## PRODUCT INFORMATION BULLETIN

**Bulletin Number** : PIB-01-2026

**Subject** : Vigil Cutter Service Life

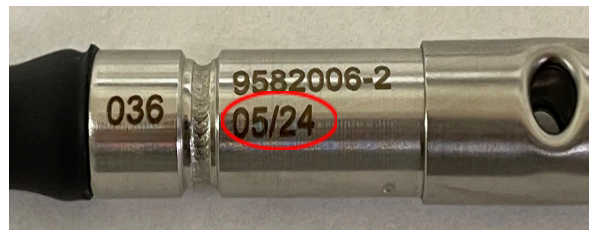
Multiple Vigil units have been returned to our Service Department, and during inspection, the units were found with a replacement cutter that had a DOM older than 6 months prior to the DOM of the Vigil unit. Use of a cutter that is older than 6 months prior to the DOM of the Vigil unit could possibly result in the cutter exceeding its Service Life

Vigil cutters placed on any Vigil unit should not be older than 6 months prior to the DOM of the Vigil unit.

New or used Vigil AADs with a cutter DOM older than 6 months prior to the DOM of the Vigil unit should not be installed in any parachute rig.

If the age of the cutter exceeds 6 months prior to the DOM of the Vigil unit, the complete Vigil unit should be sent back to the factory for servicing and cutter replacement. For Vigil 2+ AADs, the cutter can be replaced in the field.

The expected Service Life of a Vigil cutter is 20 years + 6 months.
